RE: **Monterey Place Apts**
2306-2320 Central SW
Grading Plan Stamp Date: 11/13/19
Drainage Report Stamp Date: 11/13/19
Hydrology File: J12D030

RE: Monterey Place Drainage Submittal for Building Permit (Hydrology File: J12D030)

RE: Monterey Place Apartments (Hydrology File J12D030) Revised Grading and Drainage Plan

SHEET TITLE
DETAILED
GRADING PLAN

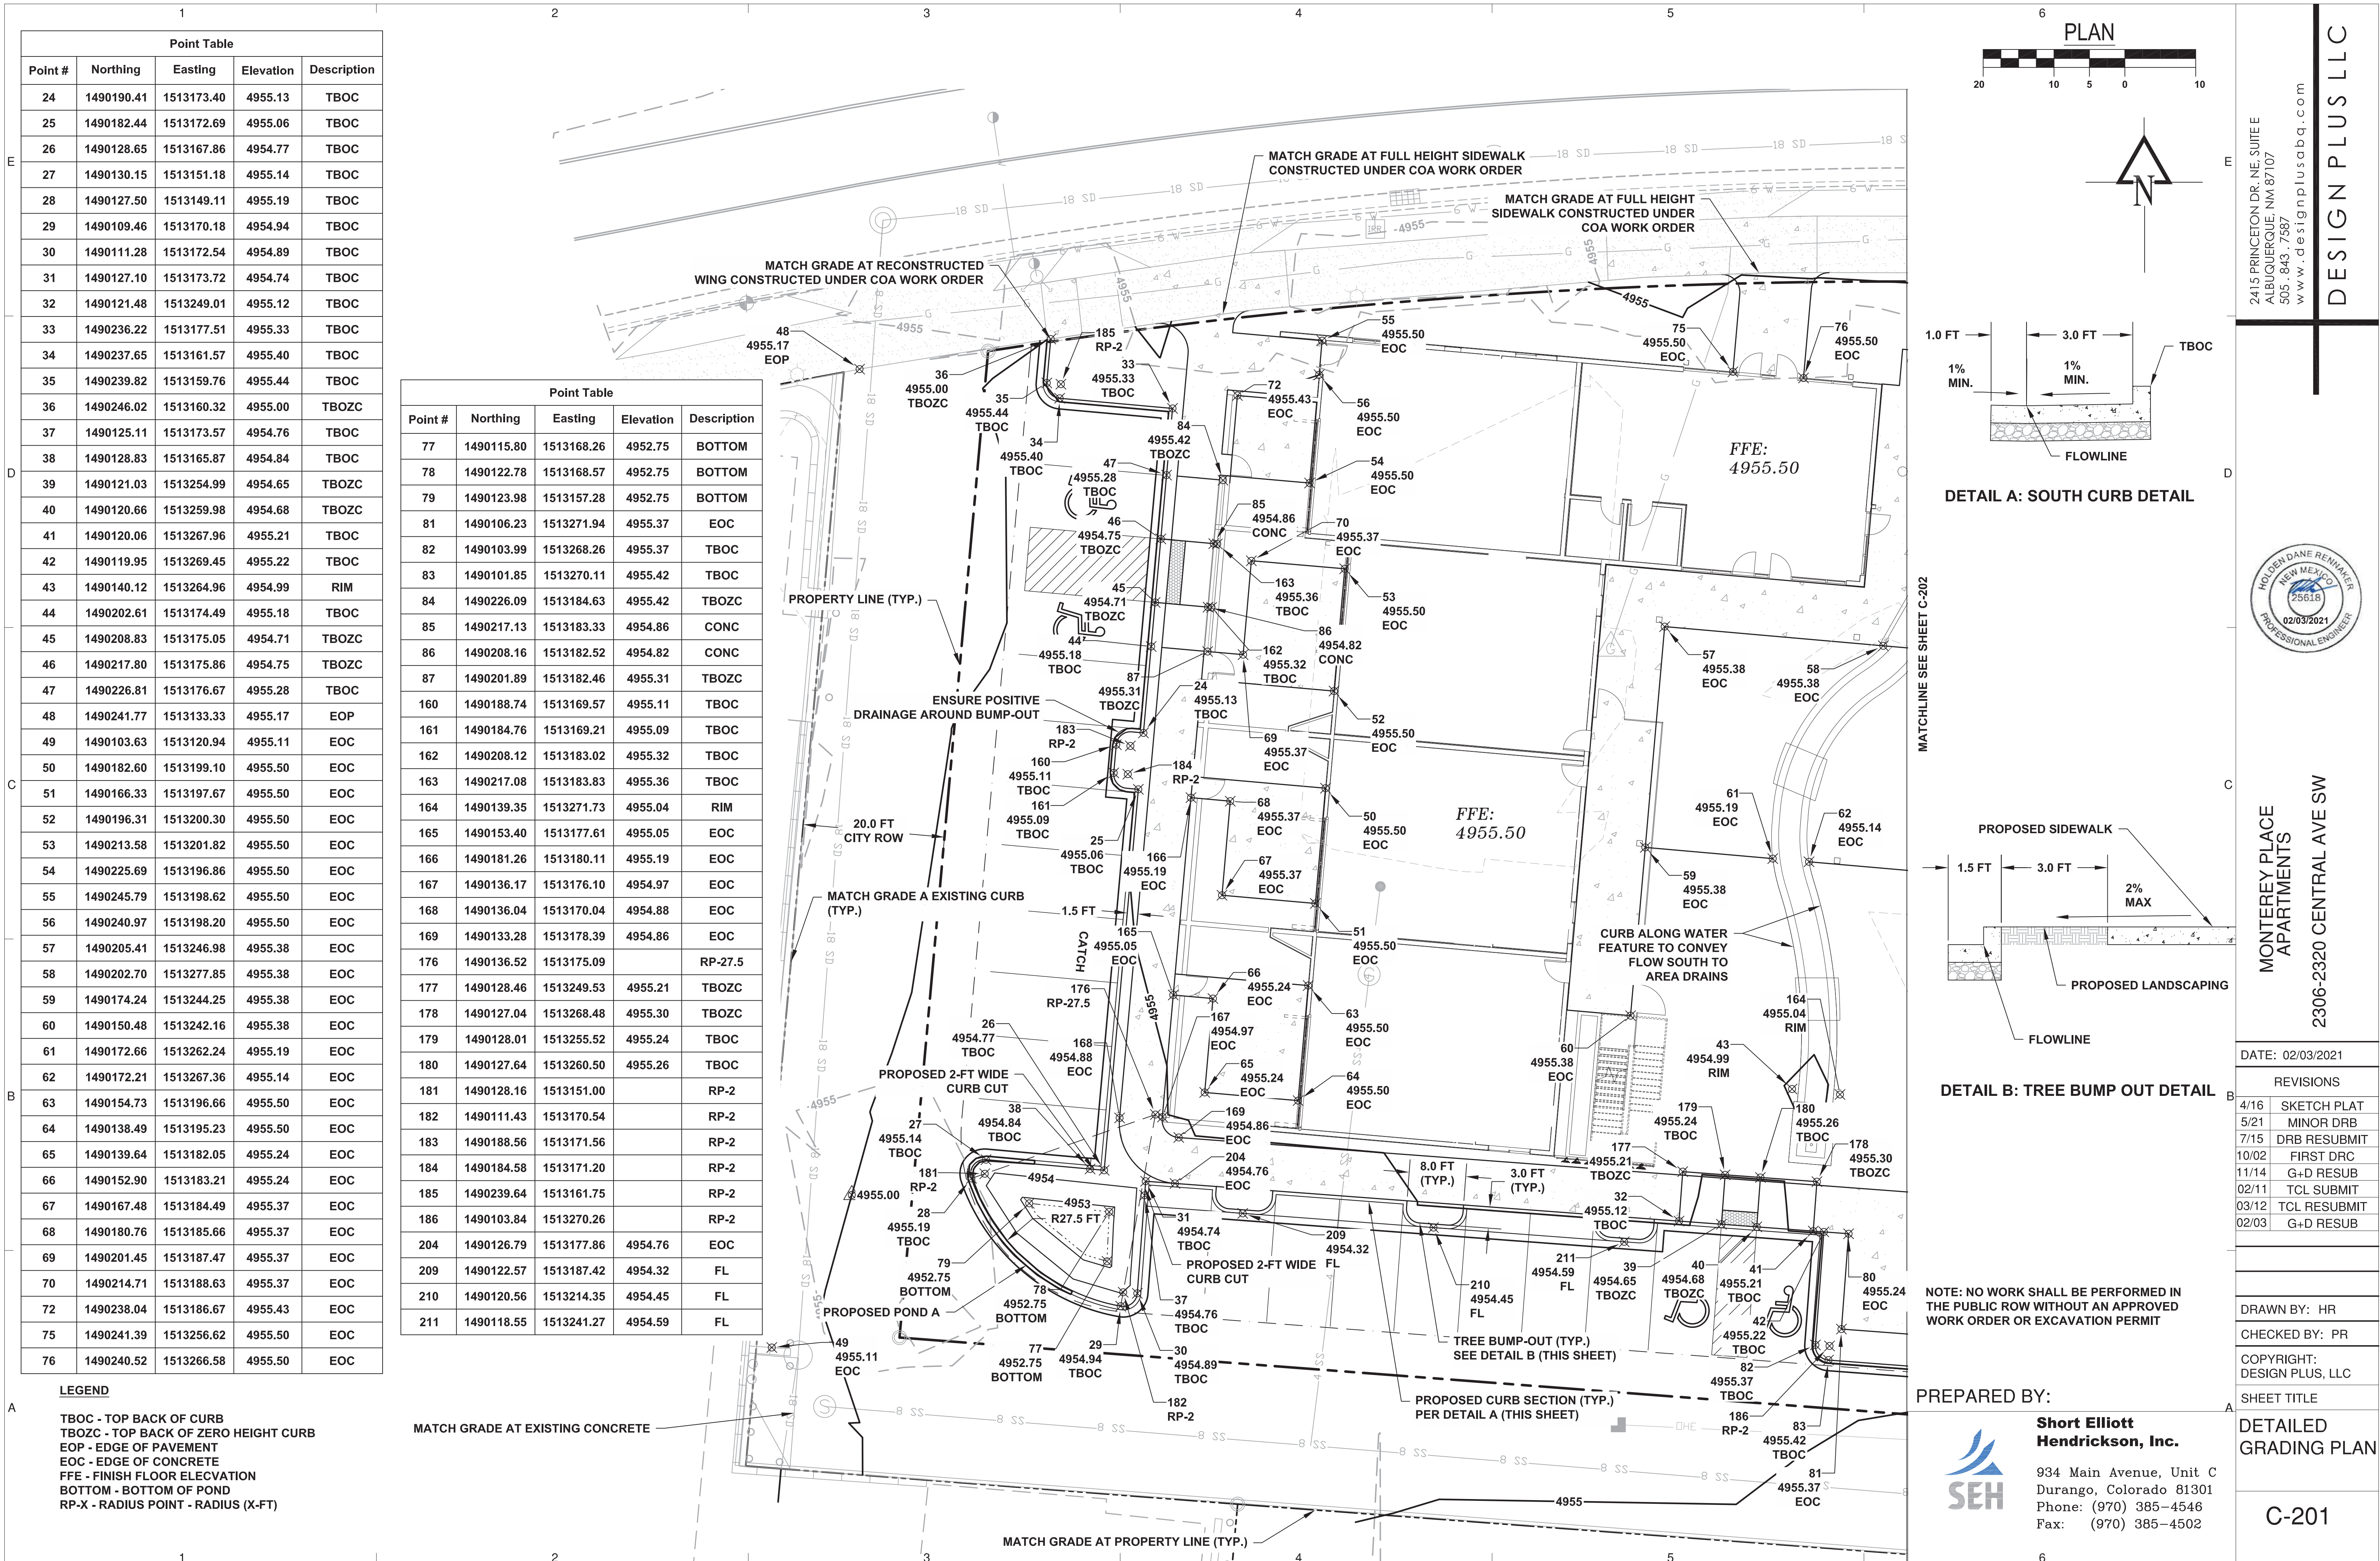
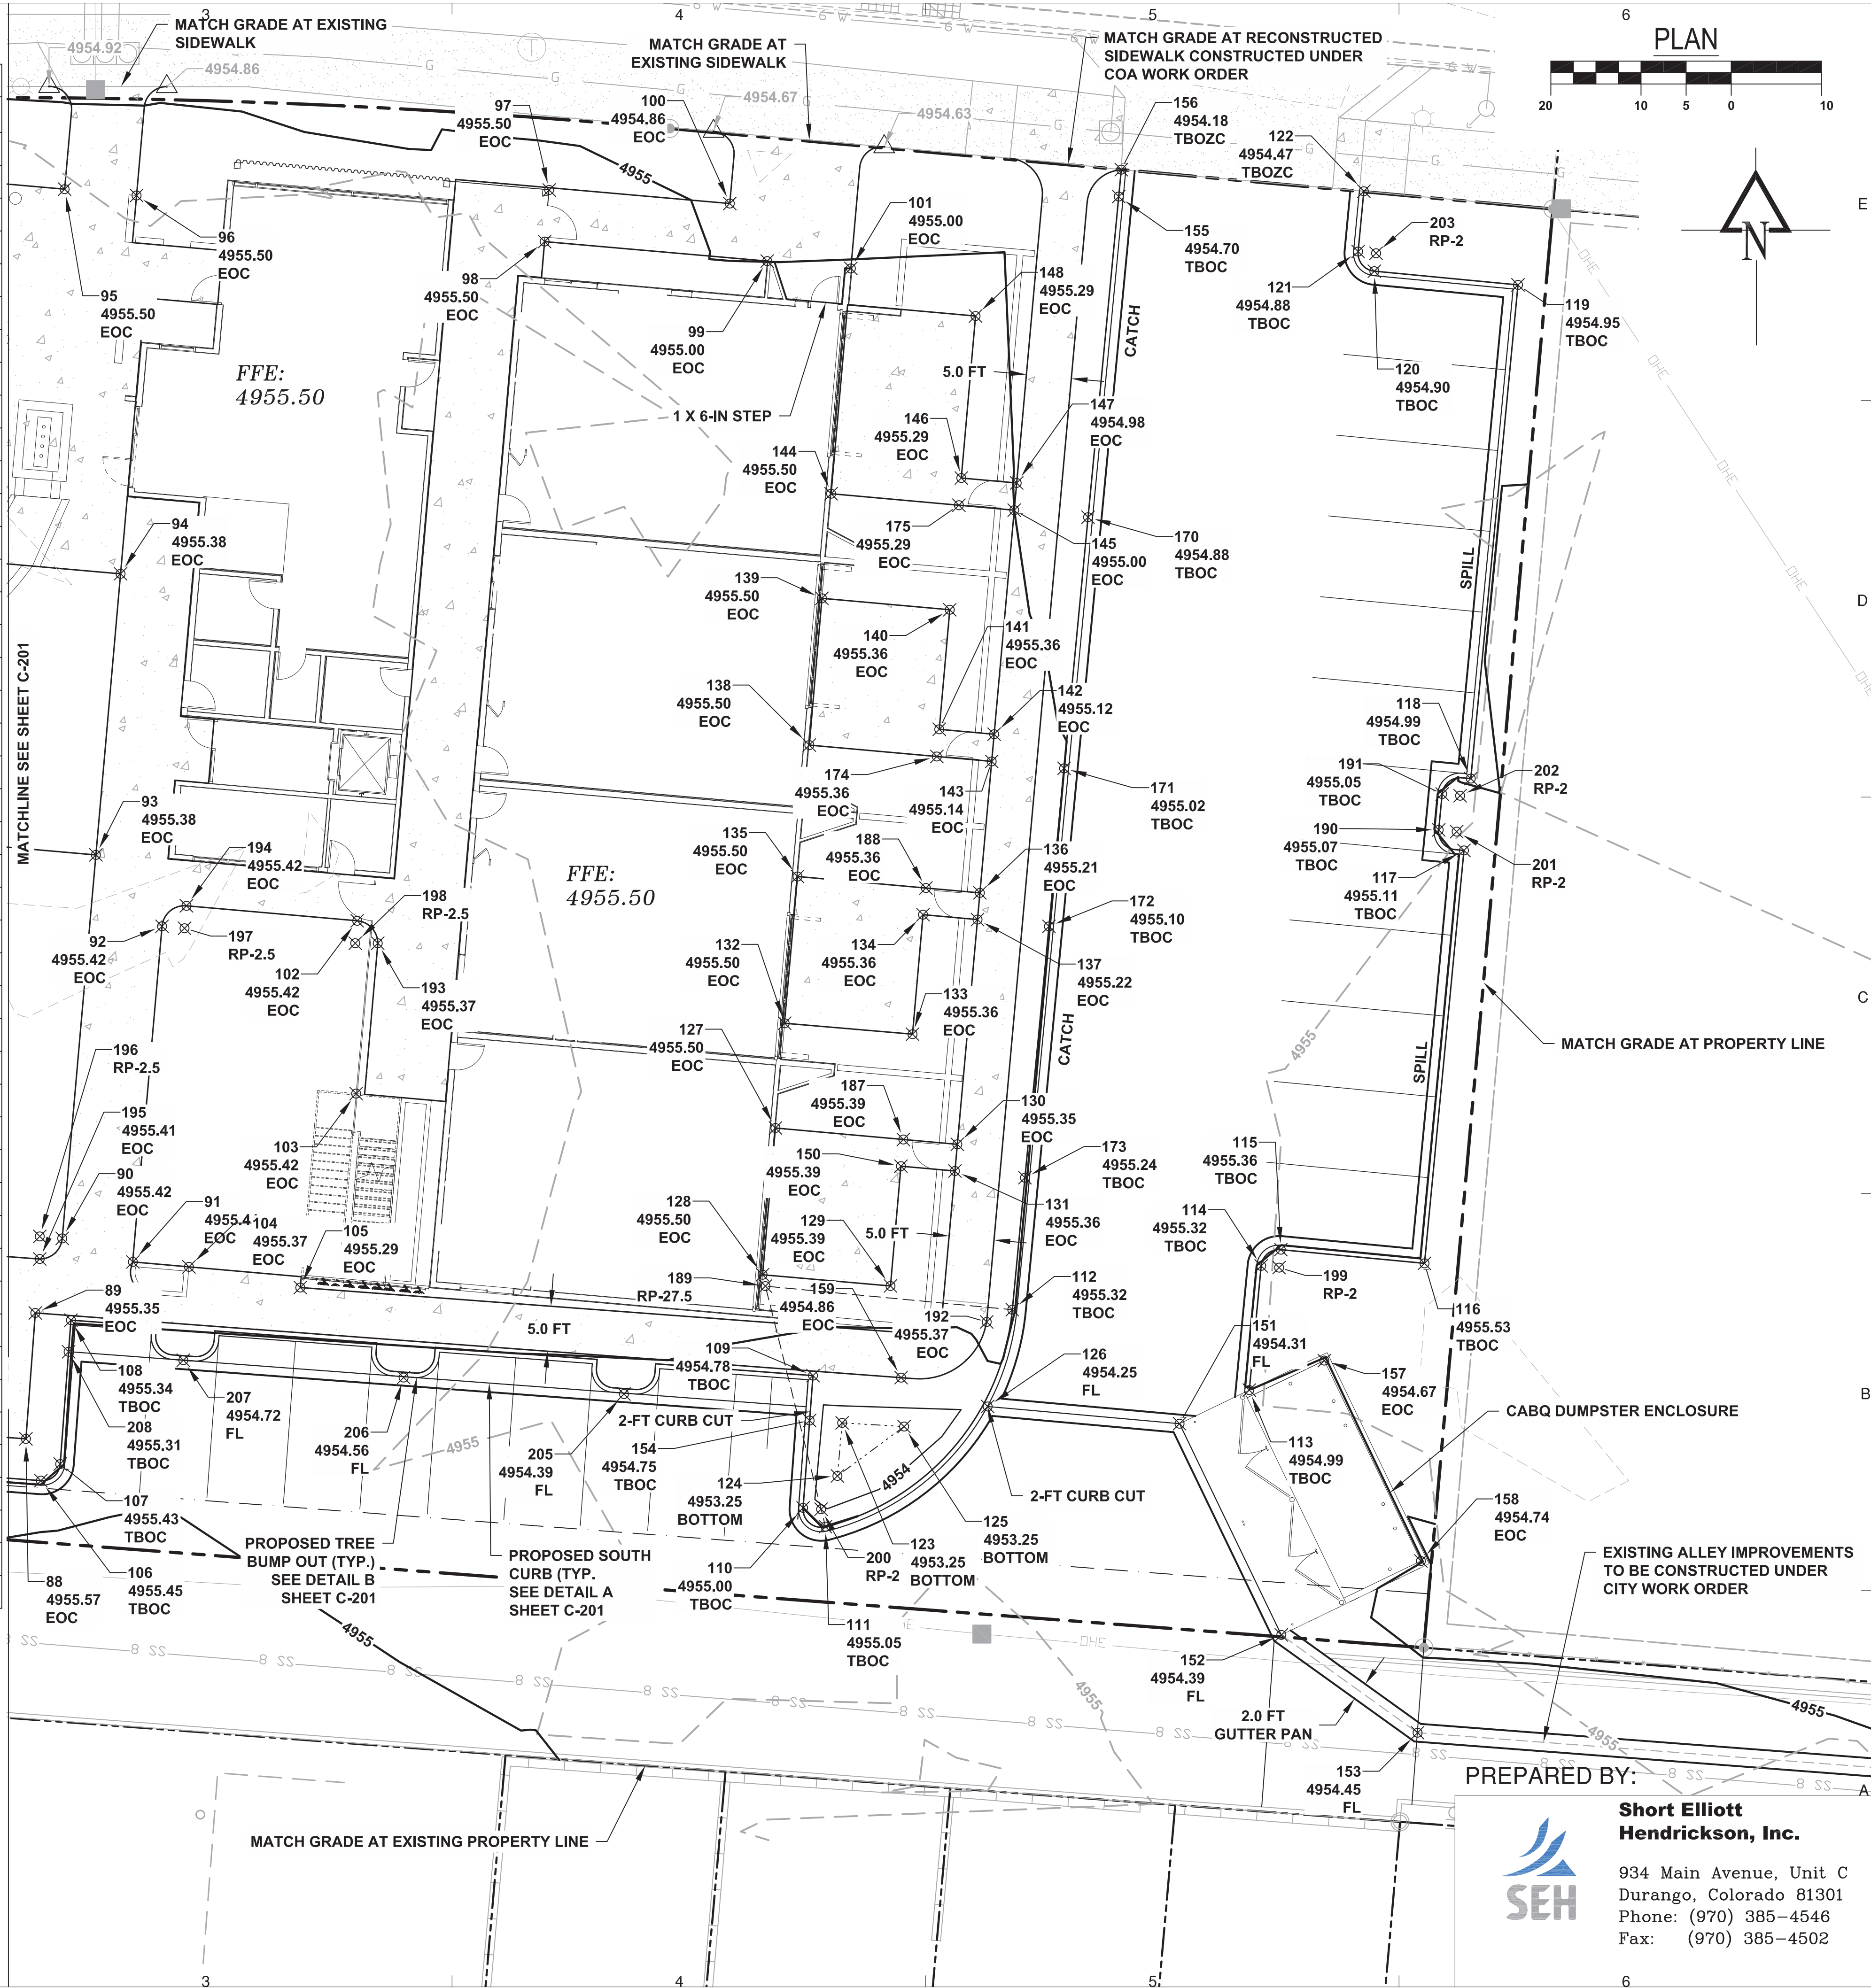
Recent field discoveries have prompted the need for a minor revision to the Grading and Drainage Plan, approved November 21, 2019, for the Monterey Place Apartments. In short, an existing storm drain manhole was discovered in the SW corner of the alley that was previously unknown. This manhole is downstream of the inlets in Central Avenue, proposed to be tied into per the approved plan.

The revised plan calls for a tie-in to this storm drain manhole for some of reasons mentioned below:

- Overall improved internal storm drain system (outlet is now at the low point of the site, there is less opportunity for clogging and the tie-in is 6-in above City storm main invert for less opportunity for back up)
- Reduced impact to Central Avenue Right-of-Way
- Reduced chance of utility conflicts with existing utilities in Central Avenue ROW

Overall, the hydrology of the site, basin delineation, and land cover remain unchanged from the approved plan, as there were no surface flow changes. The “*Storm Drain Lines A and B*” section of the approved *Supplemental Calculations and Findings Package* should be revised to read as follows:

“Two separate 12-in PVC storm drain lines were designed to convey flow from the site to the existing City storm drain system. Storm Line A was designed to collect flows from Basins A and B and convey them to an existing storm drain manhole at the southwest corner of the site. Storm Line B was designed to collect flows from Basin D and convey them to an inlet in Central Ave. The *Hydraflow Storm Sewer Extension for AutoCad Civil3D 2018* was used to model each of the proposed storm drain lines and calculate the Hydraulic Grade Line of each system during the 100-
